ADDENDUM 1 ELEVATED REEFER PLUGS

Date: May 12, 2023

Project #: 0297.22.002

Project Name: Elevated Reefer Plugs
30th Avenue
Gulfport, MS 39501

NORTH HARBOR SITE PLAN

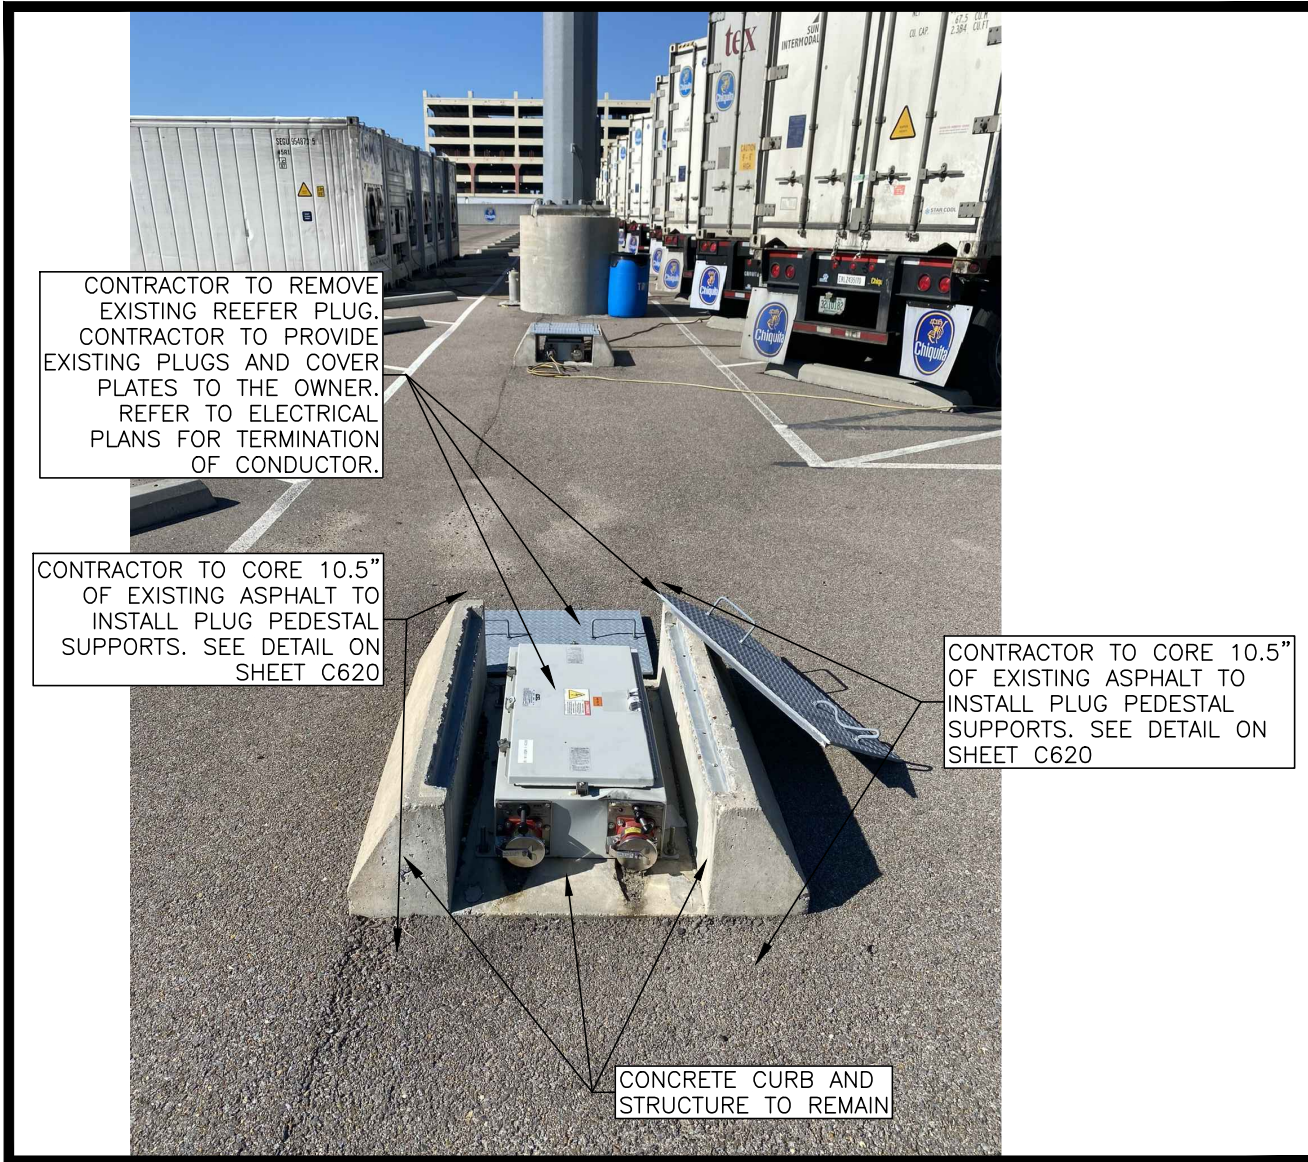
B4. Will secured laydown space be made available for this project?

Response: Yes, see attached Sheet C201 for location.

APPROXIMATE LOCATION AND SIZE OF LAYDOWN AREA. EXACT LOCATION TO BE COORDINATED WITH MSPA OPERATIONS DURING THE PRECONSTRUCTION MEETING

1 REEFER PLUG PEDESTAL DETAIL

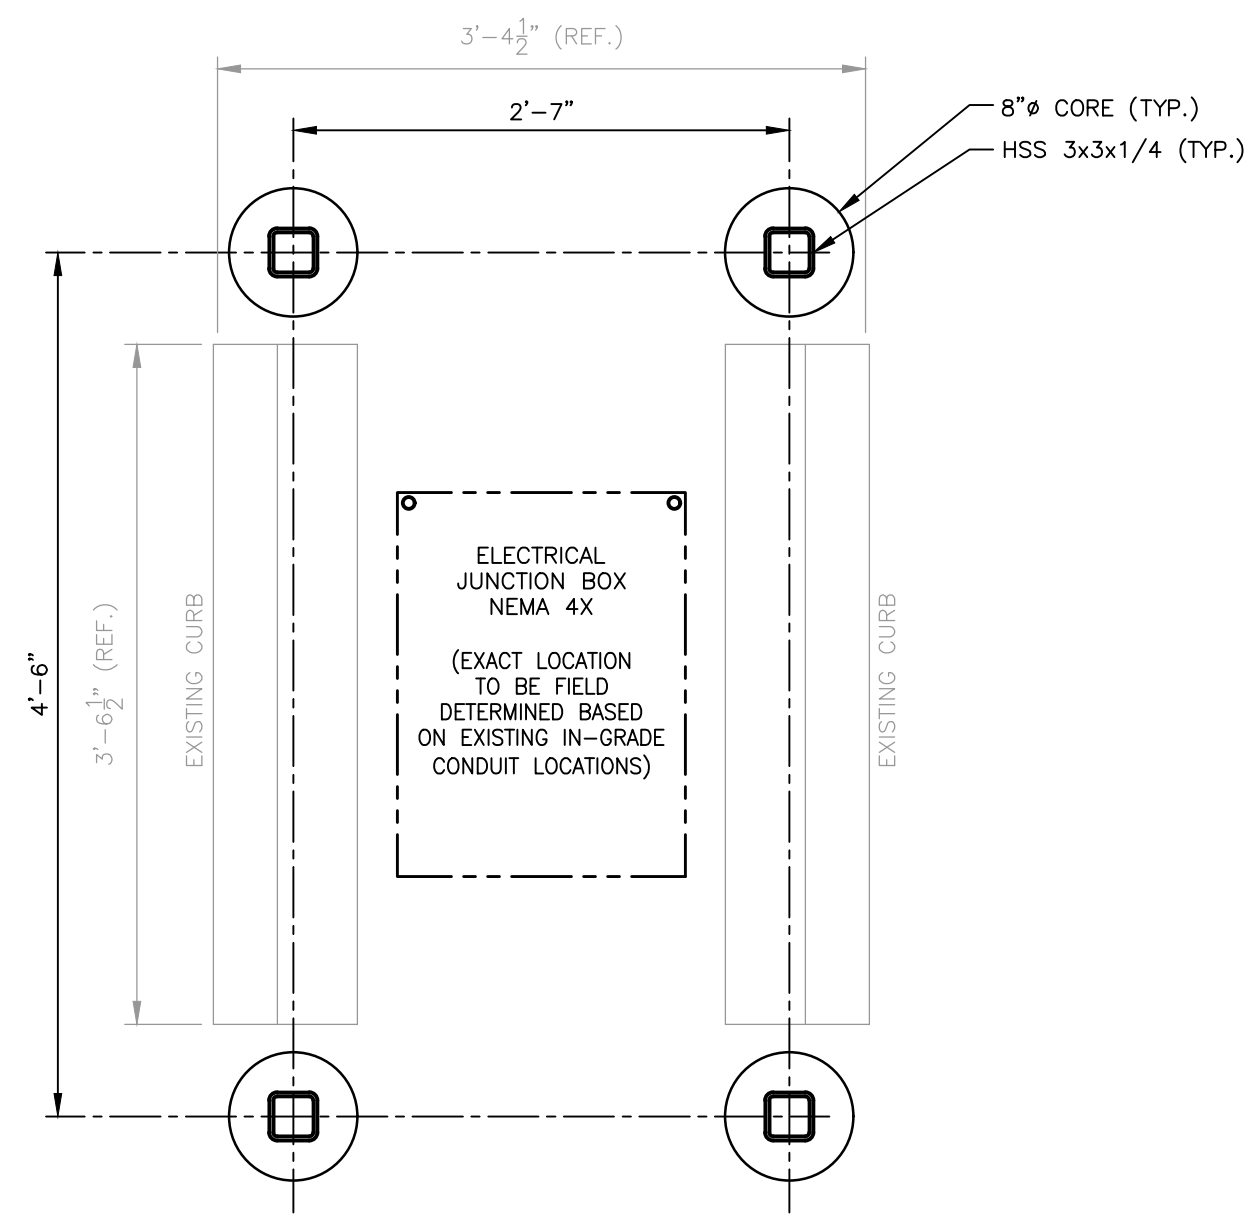
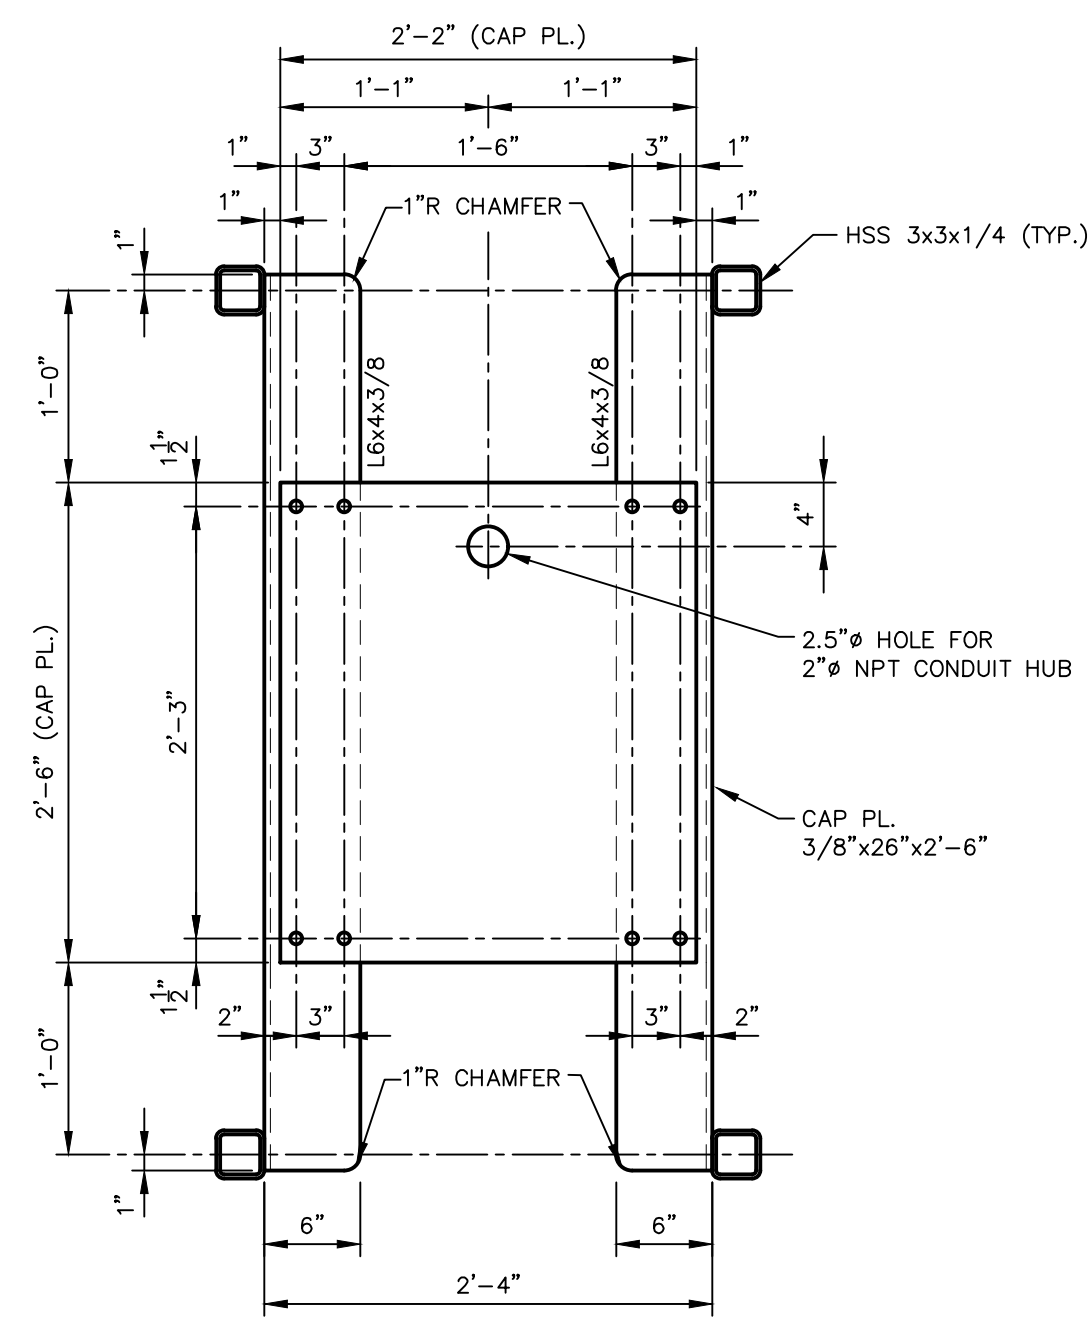
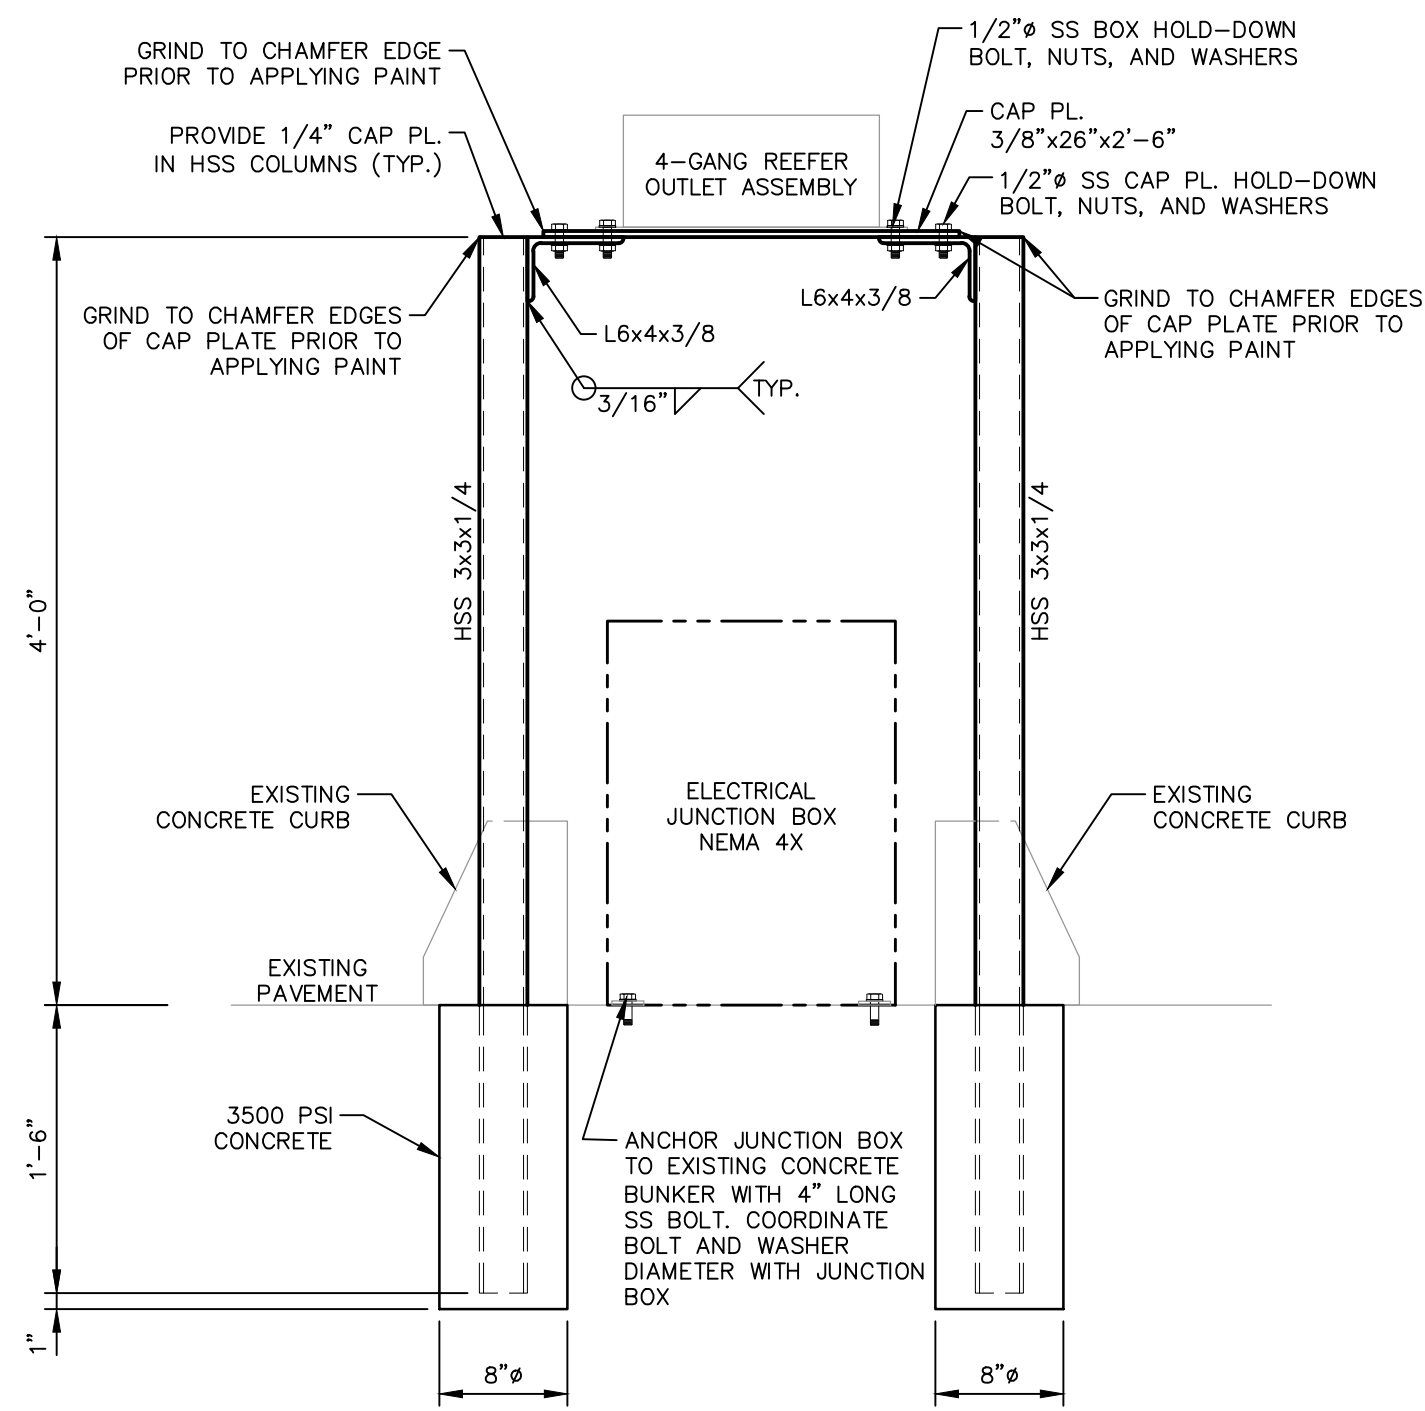
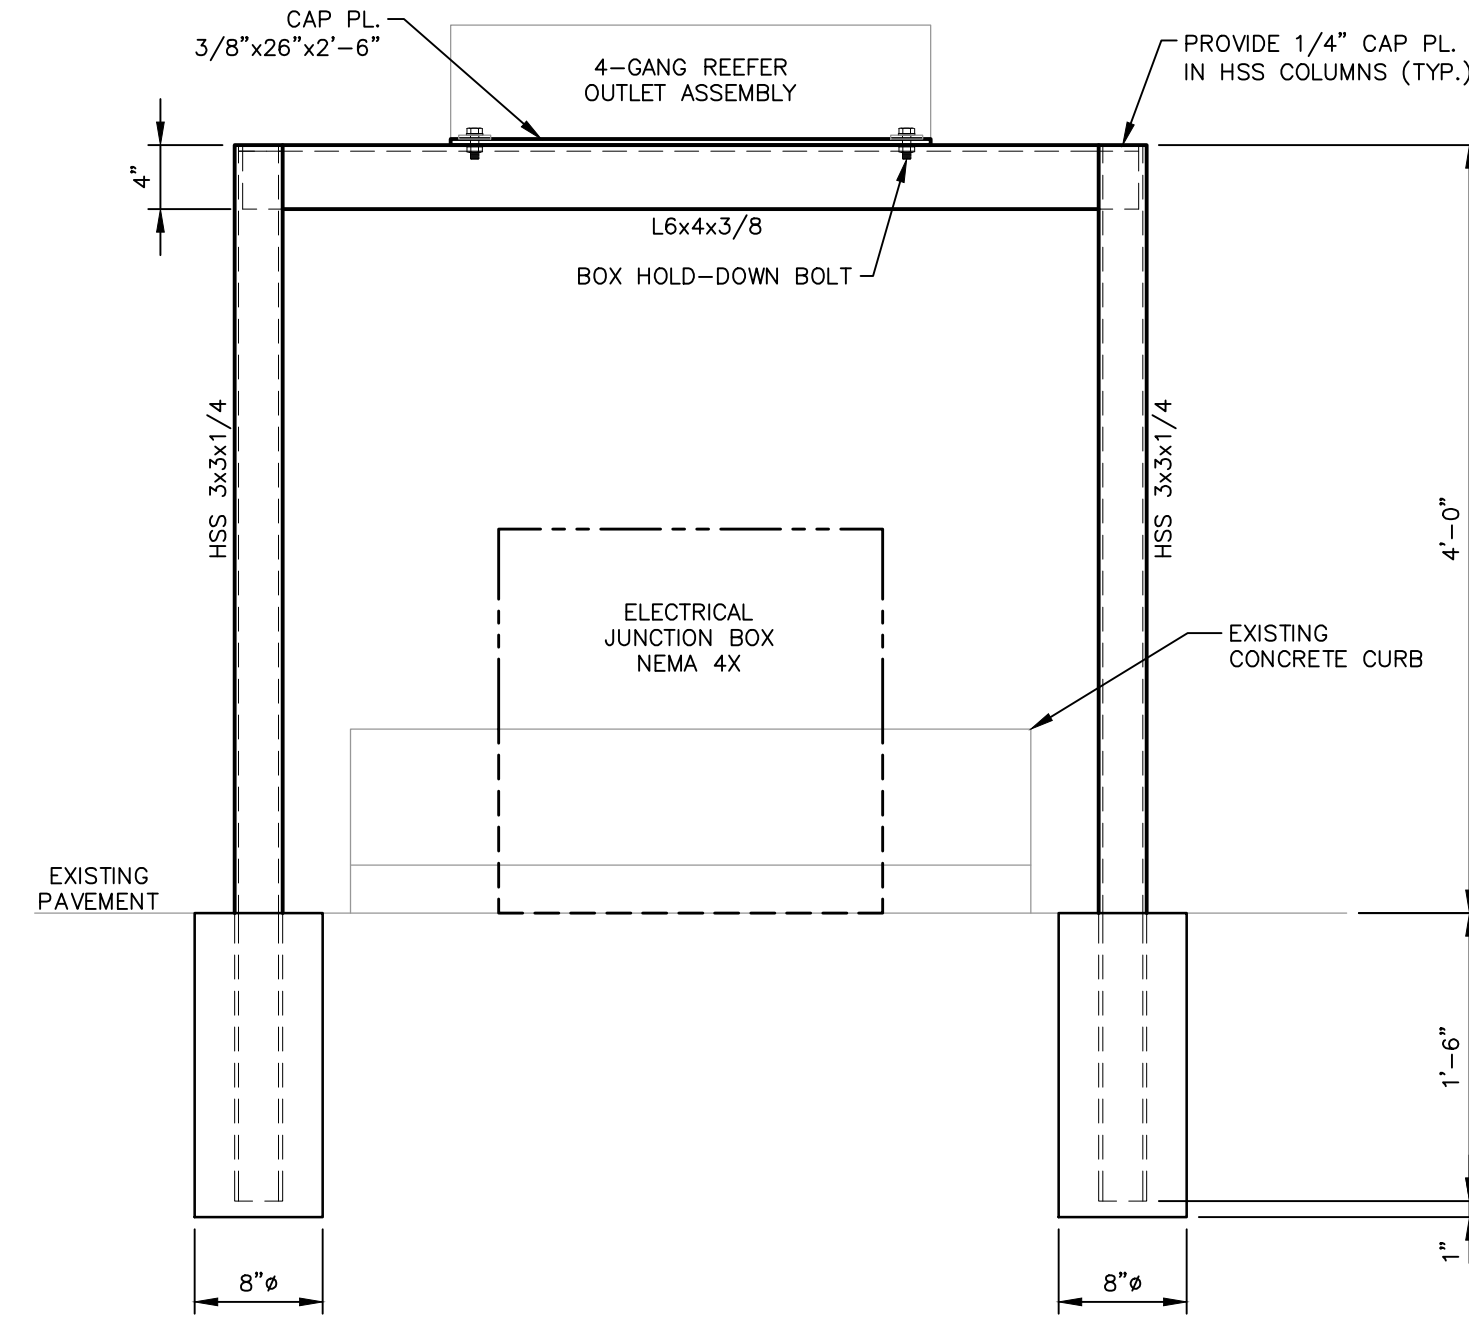
- B1. Picture on drawing C202 shows 10.5" cores for stand posts; C620 says 8" cores for posts. Which diameter is to be drilled? Is there a known depth of the asphalt
Response: The 10.5" shown in the picture on Sheet C202 is the asphalt depth, not the core diameter. The 8" shown on C620 is the core diameter.
- B2. Is the raised structure to be built with galvanized steel and cold galvanized applied or is it to be building with carbon steel and galvanized dipped?
Response: The raised steel structure is to be hot-formed structural tubing that is blasted, primed, painted. See attached spec section 055000 Metal Fabrications.
- B3. Will stored materials/advancement of materials be paid?
